QUALITY ASSURANCE -- NON-CONFORMANCE REPORT

Report No: NCR-000449

Reference Description: Missed MT indication on West Tower, Lift 3, 85.25m Diaphragm to Skin A weld

Dear: Mr. Charles Kanapicki
Job Name: SAS Superstructure

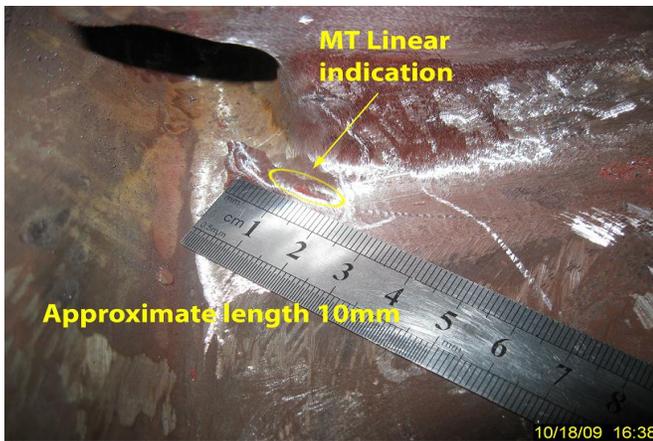
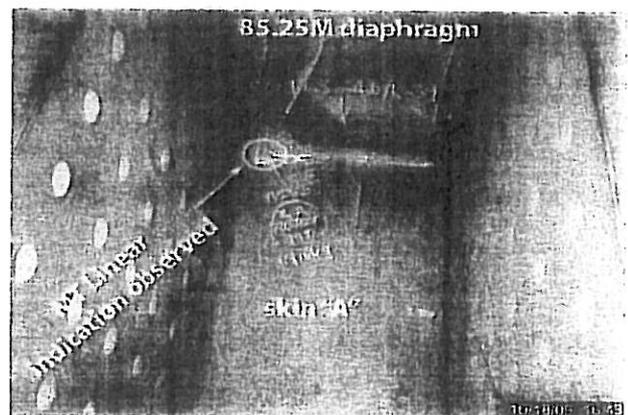
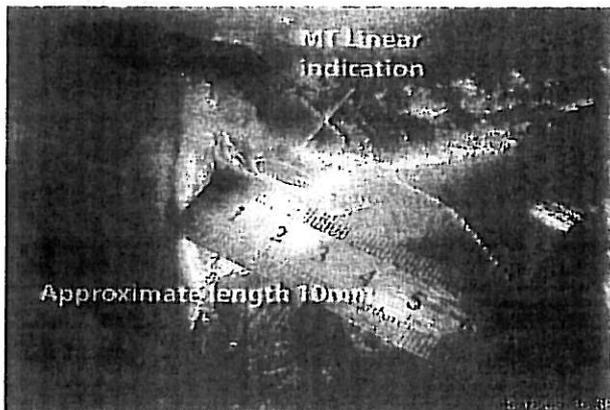
During Magnetic Particle Testing (MT) of West Tower, Lift 3, 85.25m Diaphragm to Skin A weld WSTL3-4B/K-39, QA discovered a linear indication of approximately 10mm in length. This weld had been previously tested and accepted by ZPMC NDT personnel (NDT Inspection Notification Sheet #004423).

AWS D1.5-2002, Section 6.26.2 – “Welds that are subject to MT in addition to visual inspection shall have no cracks.”

Propose a resolution for this systematic non-conformance that addresses the failure of Quality Control to identify the linear indication during magnetic particle testing of the weld. Provide documentation of the steps/actions taken by the Quality Control Manager to prevent future occurrences.

In addition to the Quality Control non-conformance, address the material/workmanship for the identified non-conformance including documentation that the deficiency has been brought into compliance with the contract requirements. Additionally address the probable causes for the indication and the actions that will be taken to limit future occurrences.

WELD NUMBER: WSTL3-4B/K-39

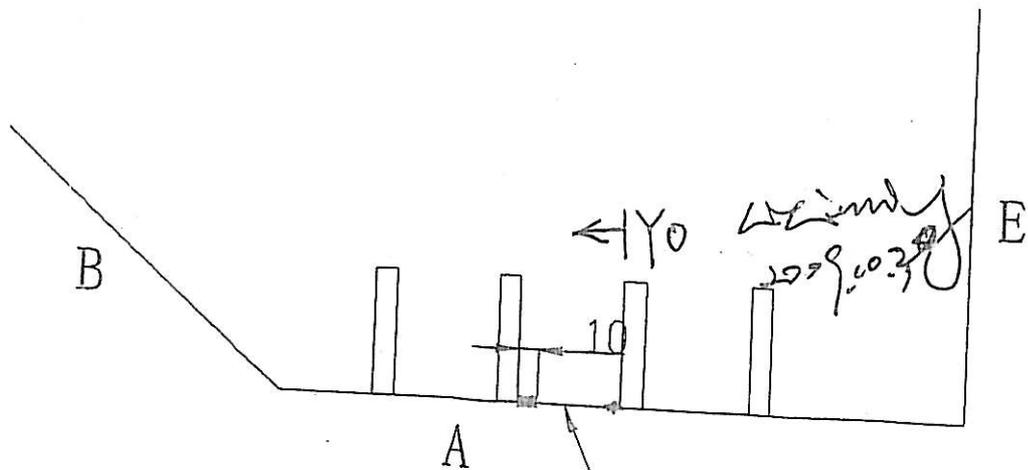
在对WSTL3-4B/K-39检测时, 发现1处纵向裂纹。L1=10mm

One longitudinal crack was found by use of MT on WSTL3-4B/K-39.

1. The access space was quite narrow resulting in making it difficult to arc-gouge the defects effectively.
2. The grinder was not observant during the grinding operation resulting in the indications not being completely removed.

1. QC shall monitor and direct the welder and the grinder doing the repair operation.
2. Preheat before gouging; the temperature shall be at least 65°C.
3. Gouge the weld to remove identified defects.
4. Joint details shall refer to the approved WPS repair.
5. Grind the gouged areas to a smooth and shiny surface.
6. Verify with VT and MT to ensure no defects remain in the weld joint prior to welding.
7. QC shall monitor all welding passes being deposited.
8. QC shall ensure all slag has been removed prior the deposition of next pass.
9. Preheat and maintain interpass temperature control in accordance with the WPS.
10. Blend the weld repaired areas into the adjacent weld or base metal by grinding.
11. Perform VT, MT and UT NDT inspection to the repaired areas.

1. Grind smoothly transition after gouging. Perform VT and MT to ensure all the defects have been removed.
2. Instruct the welder that it is his responsibility to produce sound welds and perform interpass cleaning.
3. Greater QC presence during critical welding operations.
